04-AMCP-0398

APPROVAL REQUEST FOR K BASIN INTERIM REMEDIAL ACTION DESIGN CHANGES FOR HOSE-IN-HOSE TRANSFER AND K WEST SLUDGE CONSOLIDATION CONTAINERS

**Remedial Design Report Change Description for:**

1. **K East to K West Transfer System**
2. **K West Underwater Sludge Consolidation System**
3. **K West Sludge Pumping System**

**Figure 12**

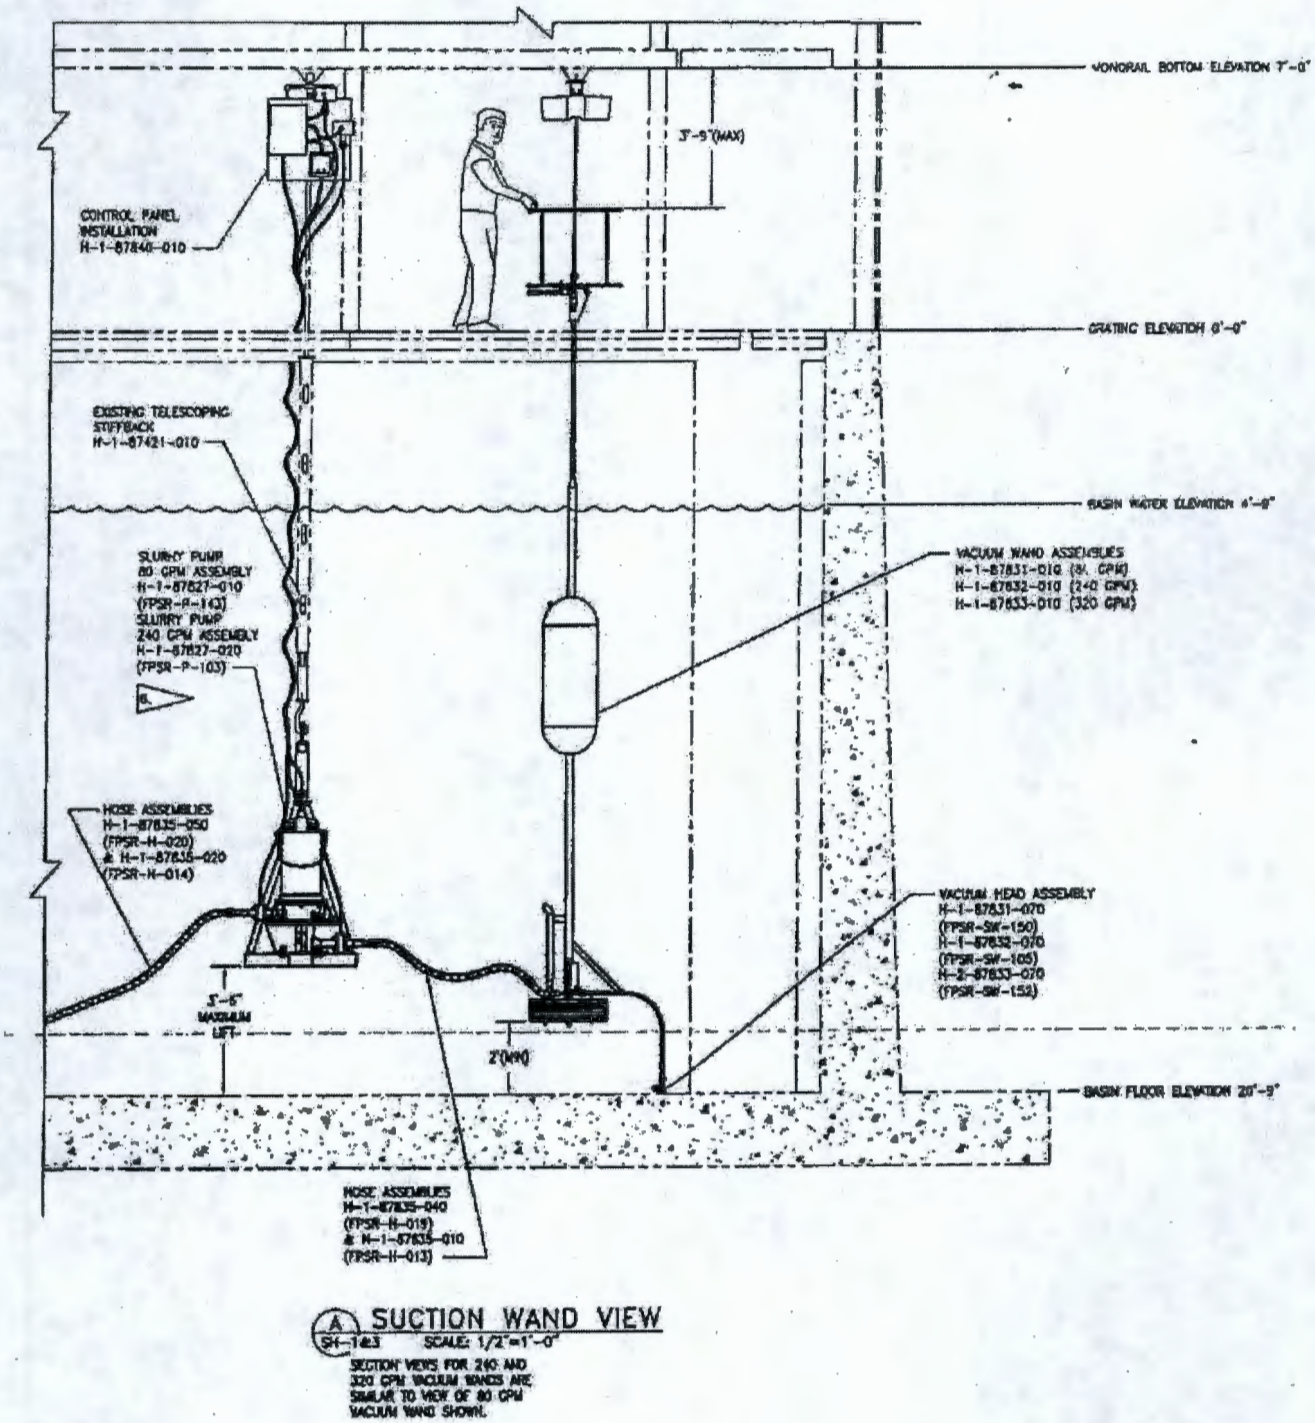
- Pump skids (Figure 11)
- Suction wand (Figure 12)
- Tie in to IWTS (Figure 14)
- Sludge consolidation containers in K West Basin for K East and K West Basins sludge (Figure 10)

### 3.3.1 Side Elevation View of the Suction Wand and Floor Sludge Retrieval System to be used in K West

**Figure 13**

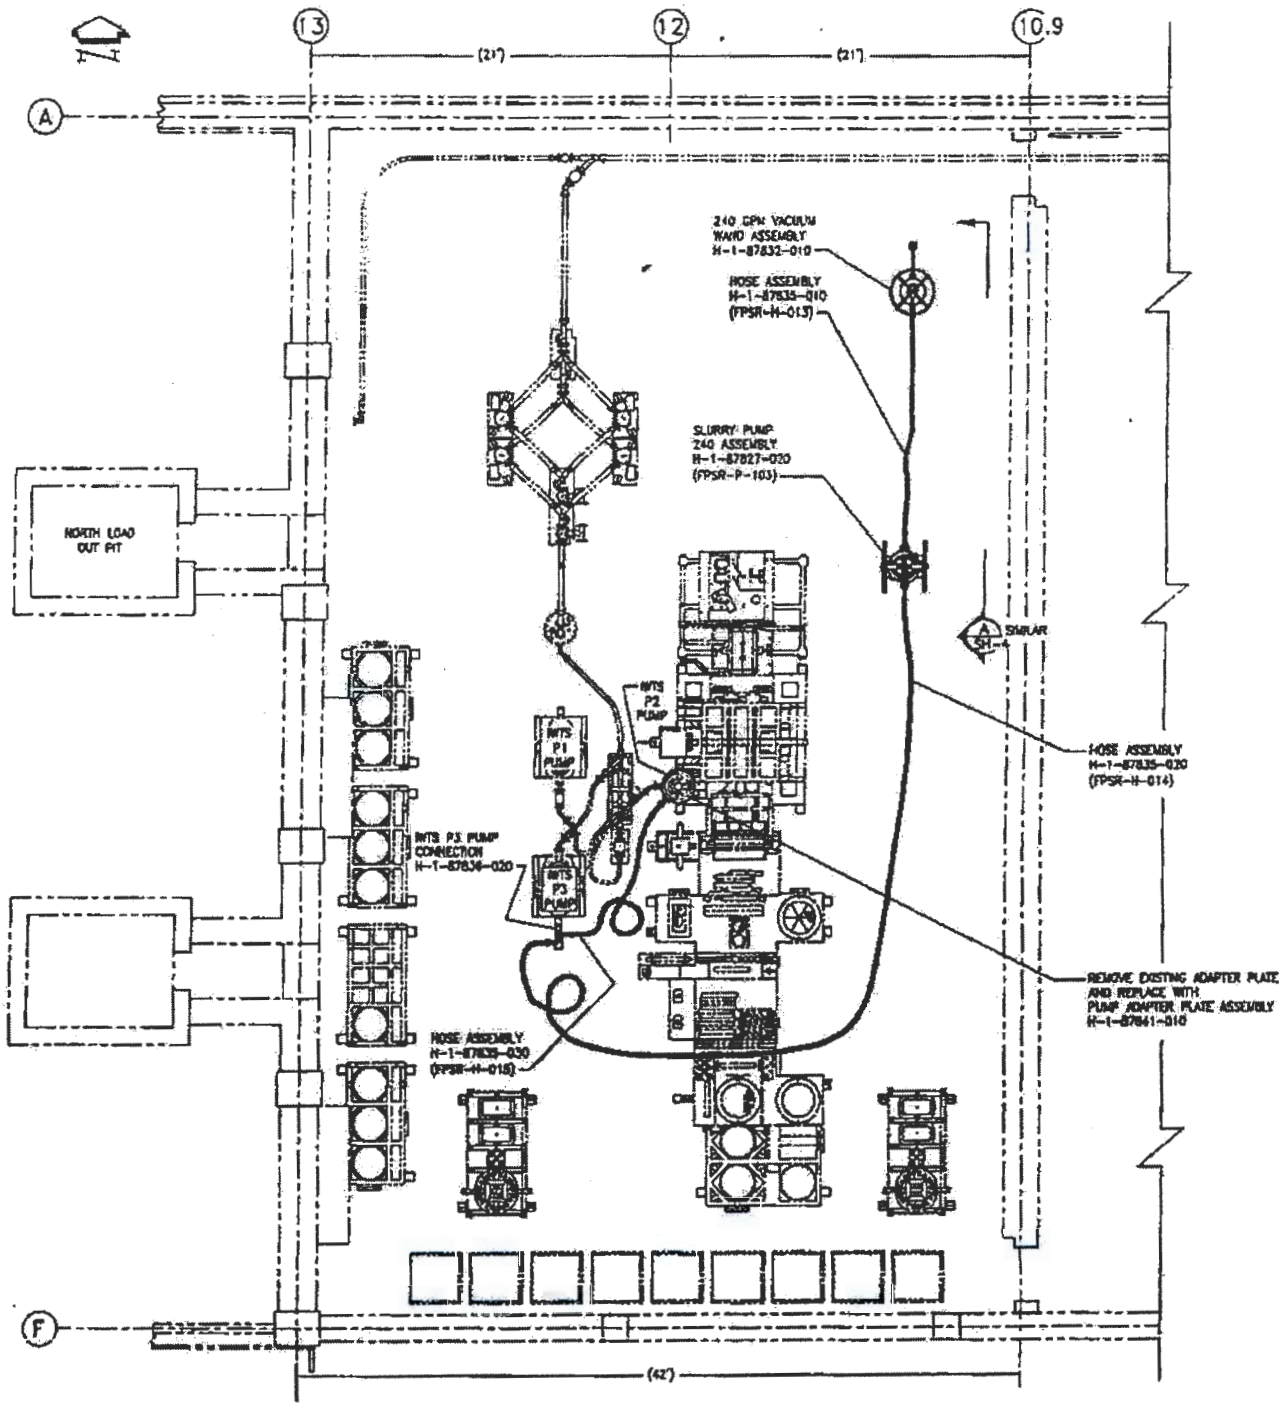
The underwater sludge consolidation containers in the 105 K West Basin will be used to hold the sludge transferred from the 105 K East Basin, as well as K West Basin floor and pit sludge with the exception of the west bay. The west bay sludge in K West Basin being metal rich will be vacuumed directly into the Integrated Water Treatment System to be collected in the knockout pots, strainers, and settler tanks.

The K West Basin sludge pumping system includes equipment designed to retrieve floor and pit sludge in the basin and transfer that sludge to either the sludge consolidation containers (Figures 8, 10) or the Integrated Water Treatment System (Figure 13) in the case of retrieving sludge in the west bay of K West Basin.
